Addendum 01 for RFQ933500-01

Project Name: DPS Oran Pape Intel Ops Room Remodel
DAS RFQ #: 933500-01
DAS Project #: 9335.00
Date: 6/14/2023

E5.1

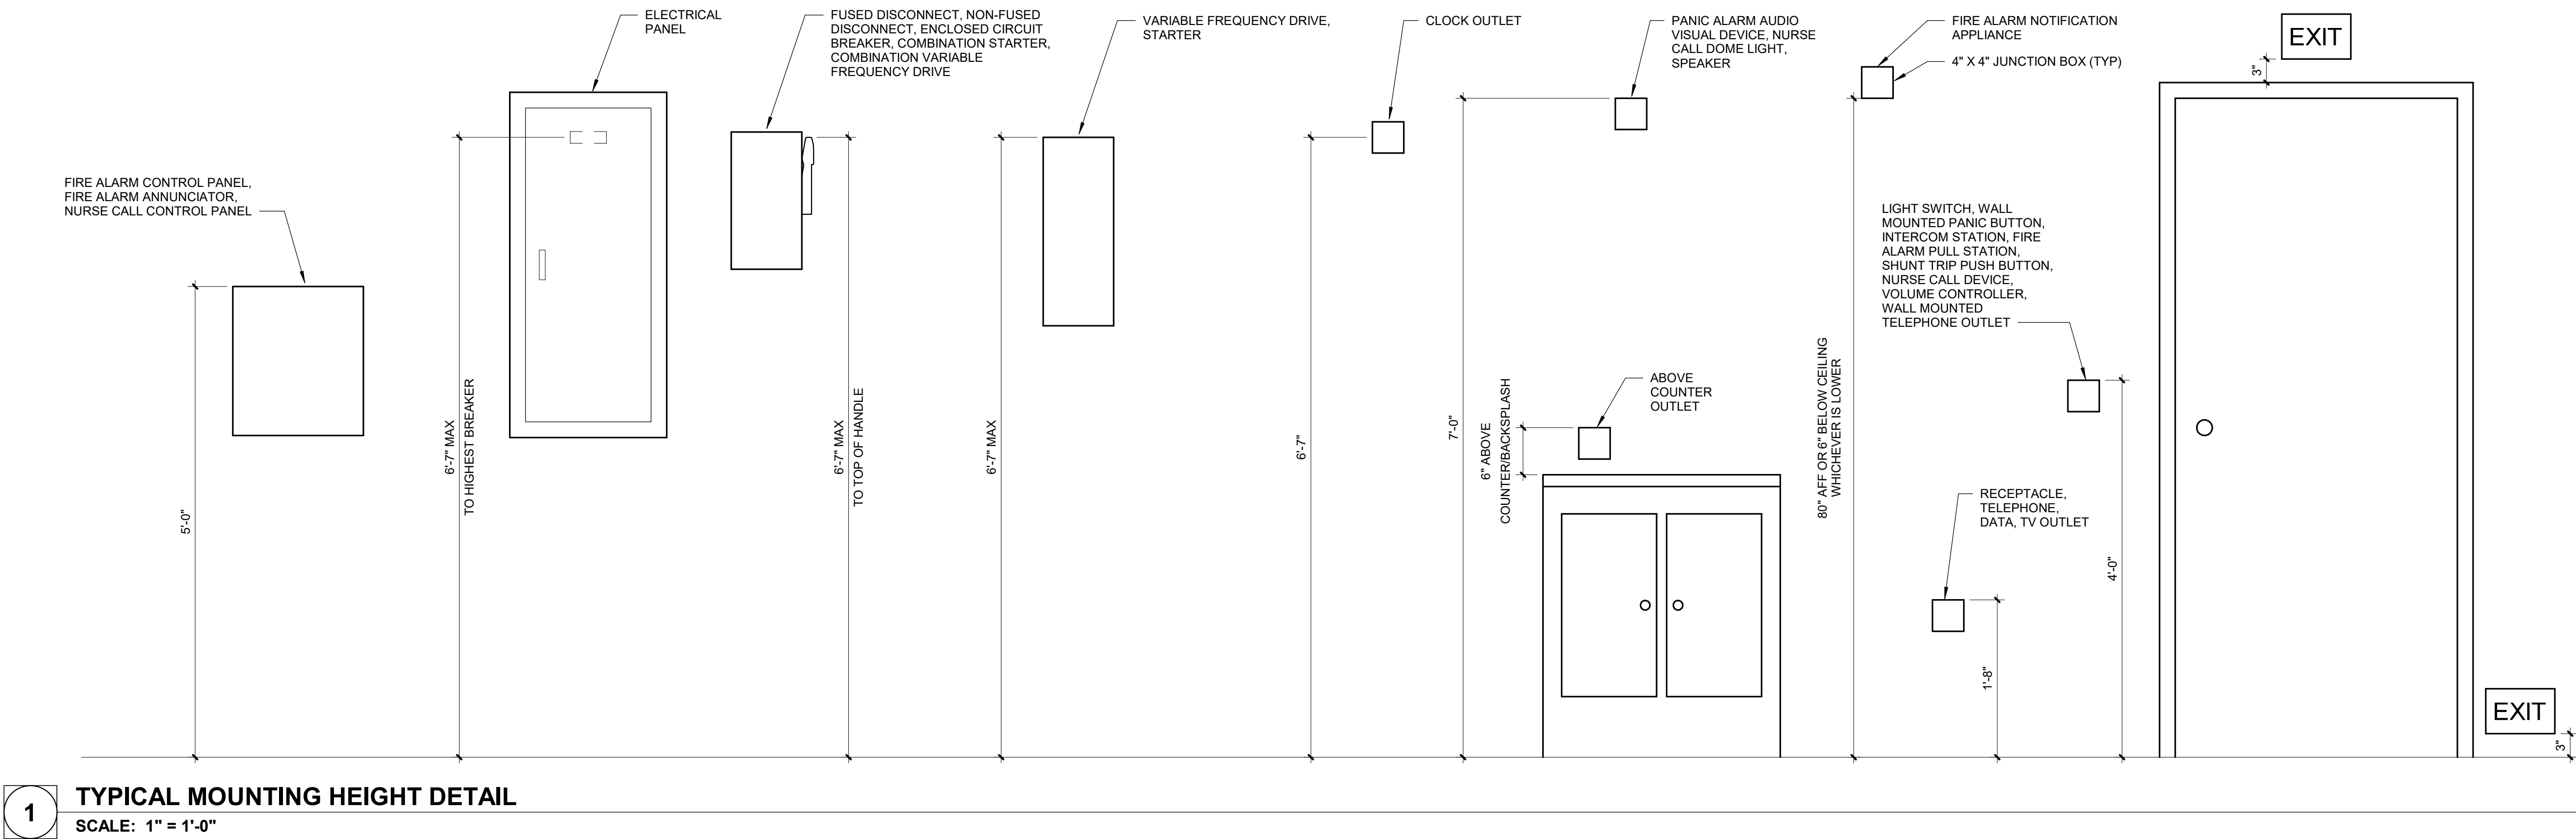
25. **ADD** CKT 39 "EF-1" to EXISTING PANELBOARD M5.
